Series B Carrier® Infinity® System Control Version 3.94 Release Notes

July 12, 2021

Revision History

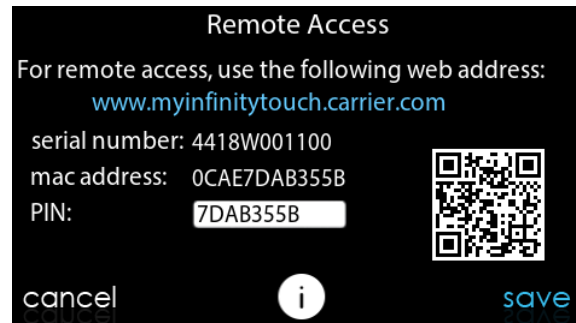
- Account registration with mobile app using QR Code on GUI

Displays a QR code on the registration info screen. The QR code contains the S/N number, MAC address, and pin number delimited by commas. The code reflects the current screen values. *Note: This feature requires the new mobile app, available soon.*
